SHX-V03	1	Vertical Stab AFT Spar	SHX-V02	A
Assembly Number	QTY Required	Part Title	Next Assembly	
Sonex Highwing Vertical Stab AFT Spar Assembly				
Drawing Scale	Drawing/Assembly Number			Revision
1:3 & Noted	SHX-V03			A

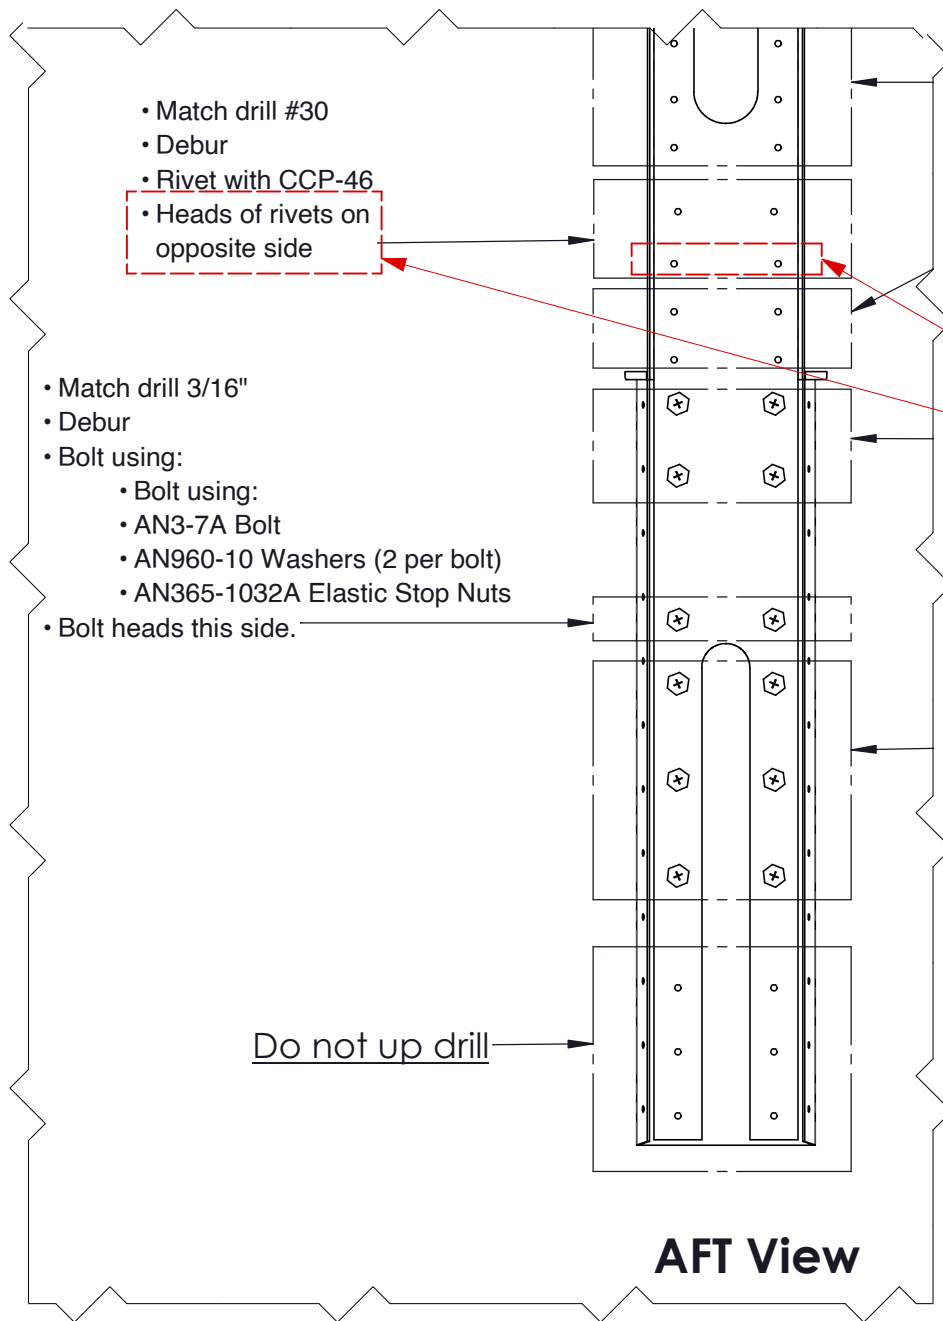
2		1		
REVISIONS				
ZONE	REV.	DESCRIPTION	DATE	APPROVED
B5	A	Changed rivet head orientation; Rivet head opposite side assigned to two additional rivets. Orientation is required to clear elevator horn at full up elevator.	1.17.26	MCS

Revision Notice:
Install these two rivets with heads of rivets on opposite side, as shown here.
